IMPORTANT!

Addendum to PG100 manual

Used on page 18

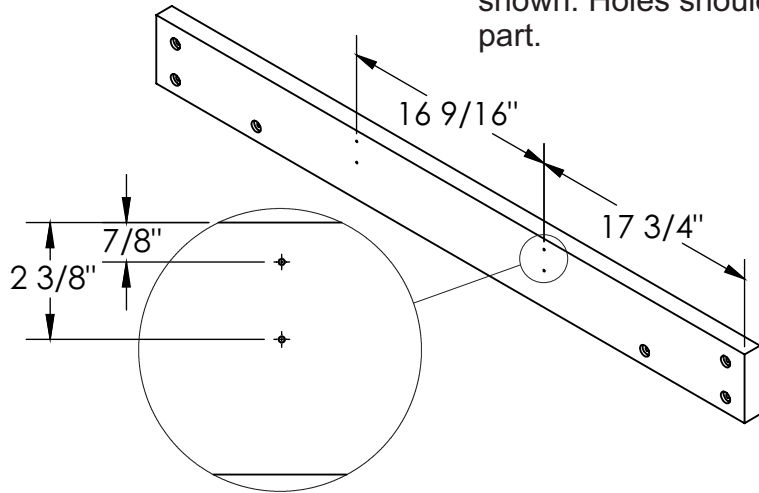
Parts #07 - 52" Main Beam are missing 4 holes. Mark and drill four 1/8" diameter holes at locations shown. Holes should be through part.

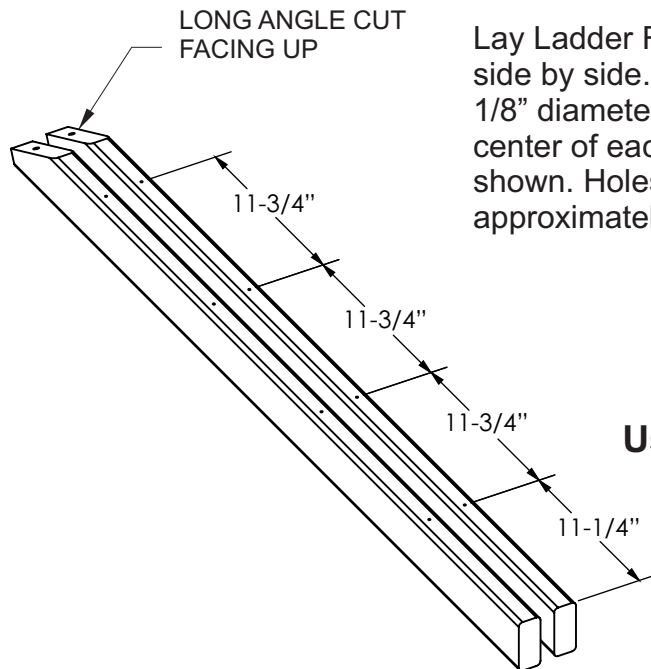
Lay Ladder Rails (PG-24-0031) side by side. Mark and drill four 1/8" diameter holes along the center of each rail at locations shown. Holes should be approximately 1/4" deep.

Used on page 18

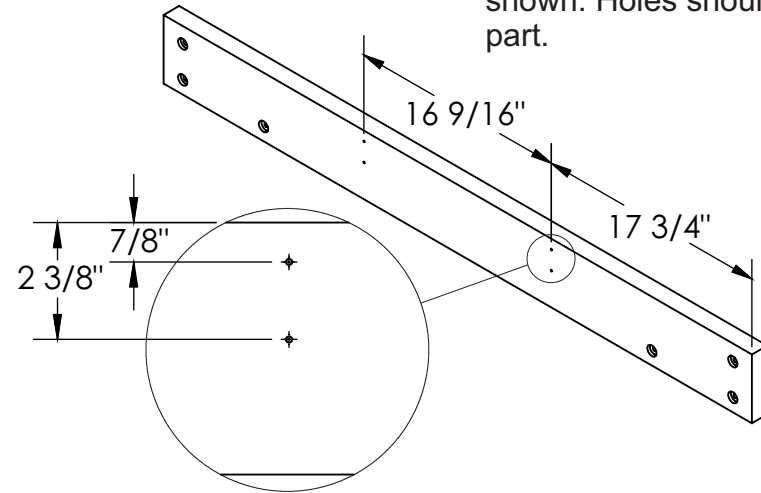
Parts #07 - 52" Main Beam is missing 4 holes. Mark and drill four 1/8" diameter holes at locations shown. Holes should be through part.

Used on page 19

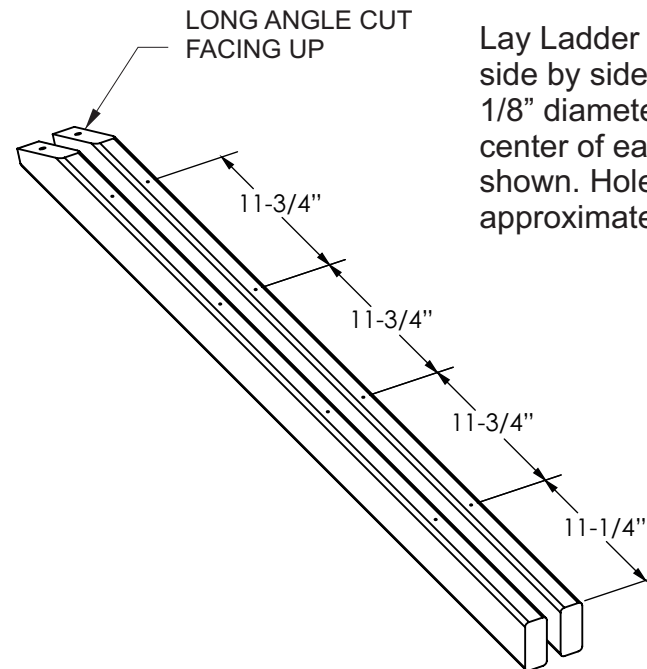
Lay Ladder Rails (PG-24-0031) side by side. Mark and drill four 1/8" diameter holes along the center of each rail at locations shown. Holes should be approximately 1/4" deep.
